SERVICE BULLETIN

No. 681

Piper Aircraft Corporation

Boom Microphone Isolation Relay

KING/NARCO RADIO INSTALLATION

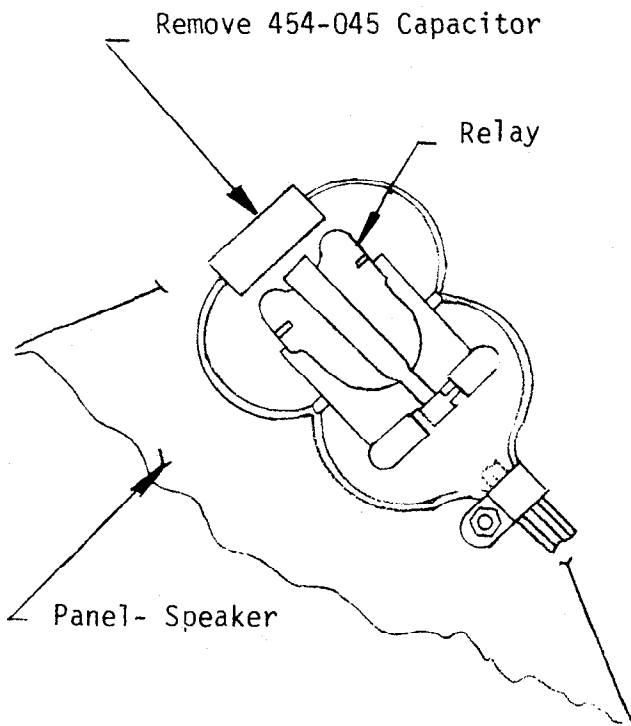
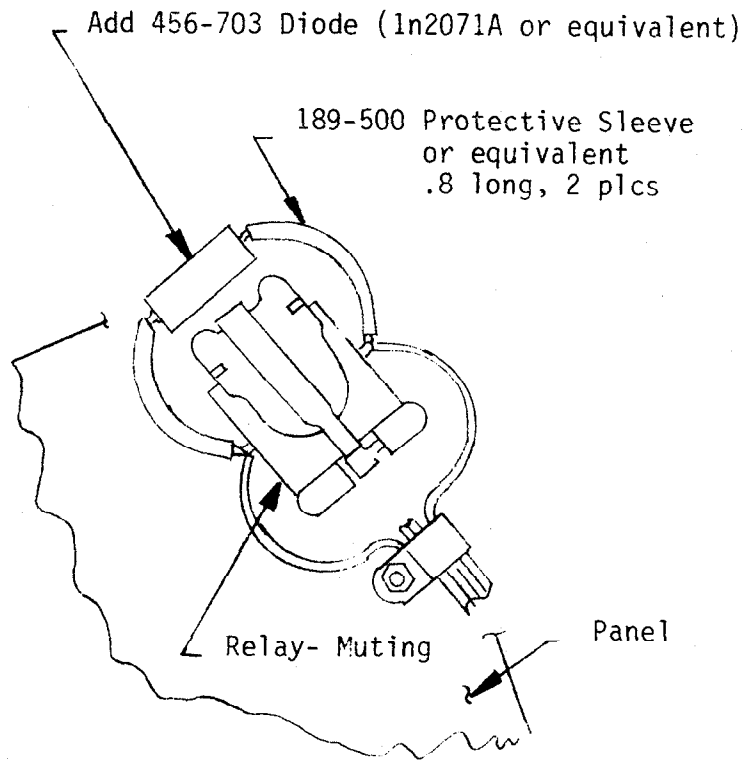
IMPORTANT: When removing capacitor, note polarity marked on shell and install diode relative to this polarity as shown in sketch 1.

4. Using proper soldering techniques:
 - A. Remove the capacitor, and on King and Narco avionics systems, install diode 1N2071A (Piper Part Number 456-703).
 - B. Diode is not required on Bendix avionics systems.
5. If Part 1 was previously accomplished, reconnect the muting relay plug and conduct radio check for proper operation.
